RE: **STAFF SUMMARY REPORT
LARGE-SCALE DEVELOPMENT PLANS – TRAILSIDE**

PROJECT NAME:	Trailside
ADDRESS/LOCATION:	4400-4426 W Oliver Drive
PROPOSED USE:	Multifamily Residential
CURRENT ZONING:	U-NBT (Uptown Neighborhood Transition)
CGM GROWTH DESIGNATION:	Commerce Corridor
APPLICANT/REPRESENTATIVE:	Crafton Tull – Daniel Ellis
PROJECT OWNER/DEVELOPER:	HCH Consulting – Hunter Haynes
PROPERTY OWNER:	HCH Consulting – Hunter Haynes
NATURE OF REQUEST:	Approval of Large-Scale Development Plans
AUTHORITY:	Chapter 14, Article III, Rogers Code of Ordinances

Re: Conditional Approval of Civil Plans
Trailside (Magnolia Town Homes Ph. 2)

EXTERIOR
 ELEVATIONS

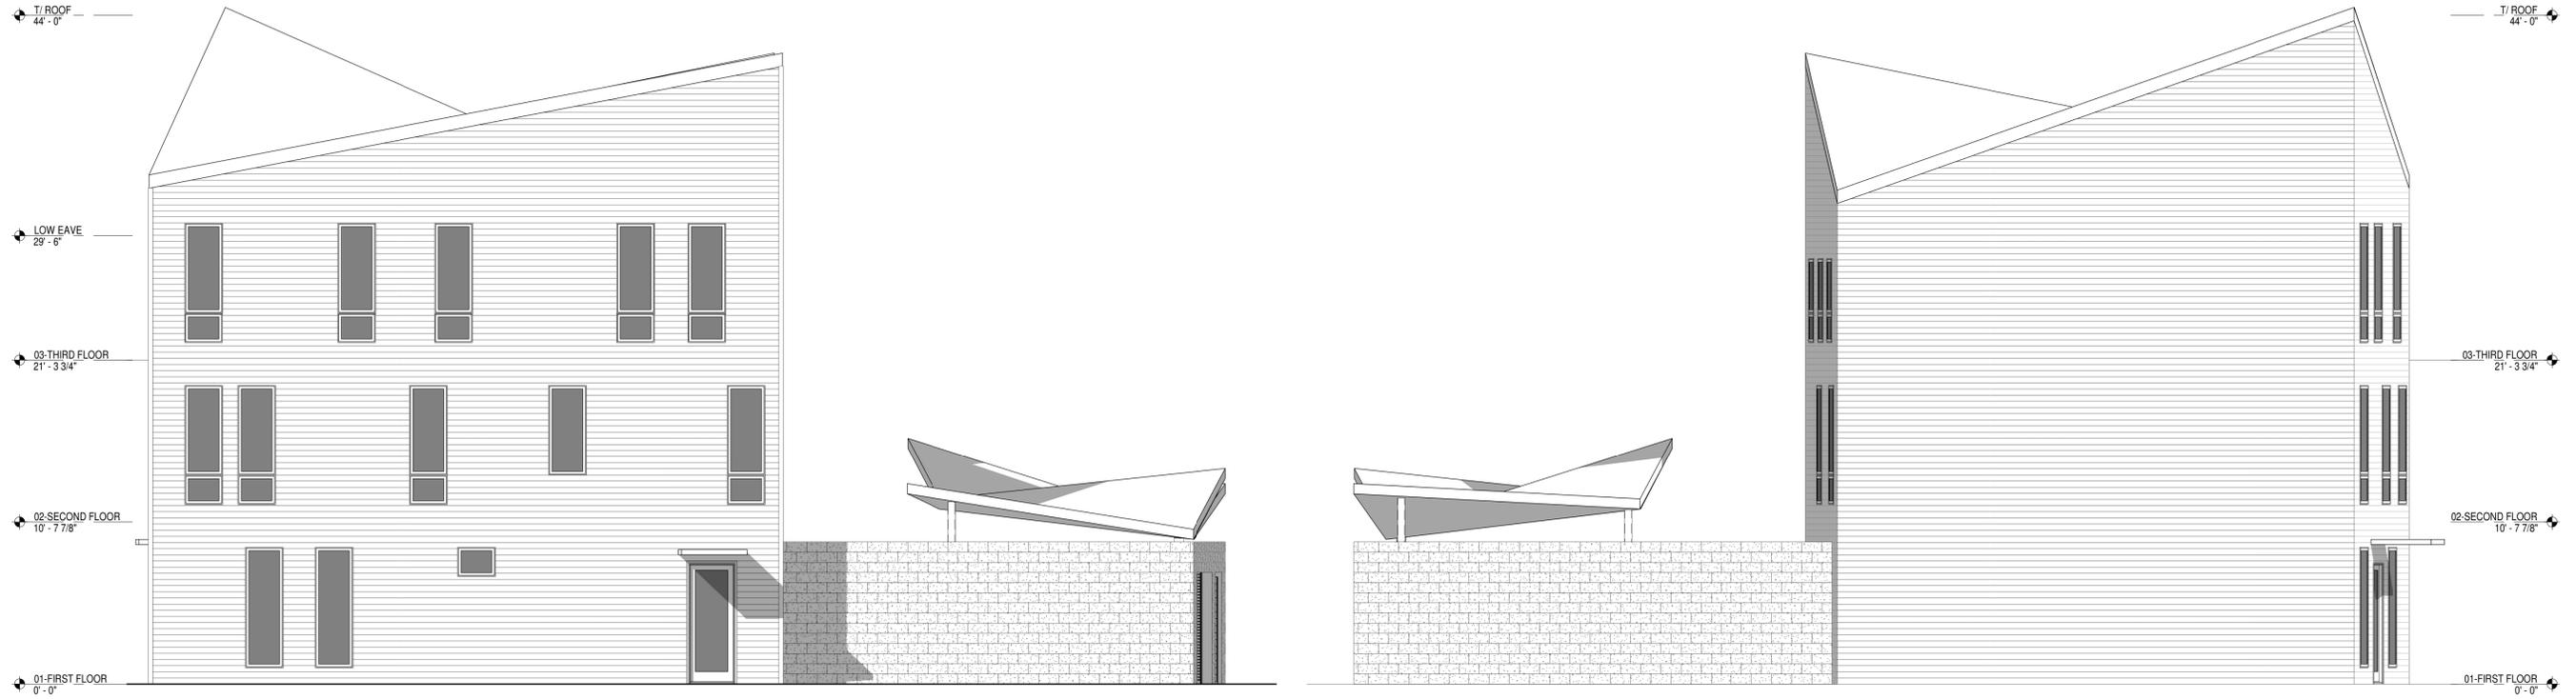
3. To allow a first floor ceiling height of less than 12' and a third floor ceiling height of less than 9'

Sec 14-732(4.5)(c)(i) – First floor ceiling height is 12' min. for all frontages and upper floor(s) height is 9' min.

We are requesting a variance from this section of the code, in order to keep the elevation of the eave of the roof under 30 ft. This will allow us to work within the Residential Fire Prevention Code rather than the Building Fire Prevention Code. The changes that would be necessary to comply with the Building Fire Prevention code will drastically change the architectural design of the development and diminish some of the amenities that would be provided to the future residents of these homes.

- iii. Approve **VARIANCE** from Sec. 14-732(4.5)(c)(i) from the requirements that the first floor ceiling height be a minimum of 12’ and all upper floors be a minimum of 9’. The proposed building has a 9’-1 1/8” first floor, a 9’-1 1/8” second floor, and a 7’-8 1/4” third floor. The applicant requests these variances in order to keep the overall building height under 30’, which will allow them to work within the Residential Fire Prevention Code instead of the Building Fire Prevention Code. The applicant states the increased height would drastically change the architectural design of the development and diminish some of the amenities that they are providing. Additionally, the intent of the building height minimum is to allow for adaptability of residential spaces into future commercial spaces. This development is very unlikely to become commercial space in the future.
